Solicitation Addendum

Addendum No.: 6
Solicitation No.: 22-TA004135DJ
Solicitation Title: Moccasin Wallow, I-75 - 301 Segment 1 from US 301 To 115th Avenue East (Copperstone Entrance)
Project No.: 6071261, 6113370, 6113390
Addendum Date: August 15, 2022
Procurement Contact: Dave Janney
Senior Procurement Agent

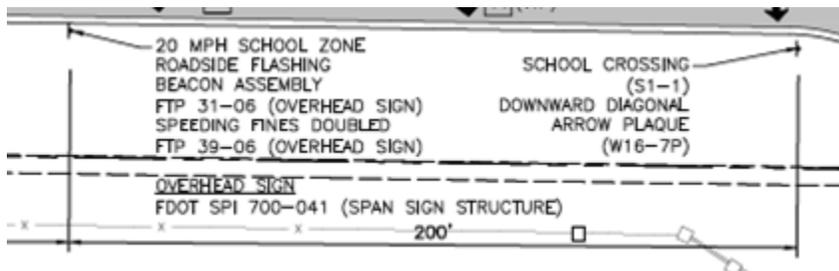
Q1. I have just noticed on plan sheet 6 of 112 a note that states “1,365.1’ (plus or minus) 30” DIP WATER MAIN TO BE GROUT IN PLACE UNDER EXISTING PAVEMENT”, there is no bid item for this scope of work. There is a Bid Item, number 122, 30” Removal CIP Watermain, but there is no reference to this bid item in specifications SECTION 01150, MEASUREMENT AND PAYMENT, to describe what Bid Item #122 is to include. It appears to us a bid item to grout fill the 1,365LF of pipe should be added to the bid form and the bid quantity for Bid Item 122 would need to be changed to reflect the amount of pipe to be excavated and removed.

R1. Bid Form Item 122.1 has been added. See attached Appendix K Bid Form Revision No. 3.
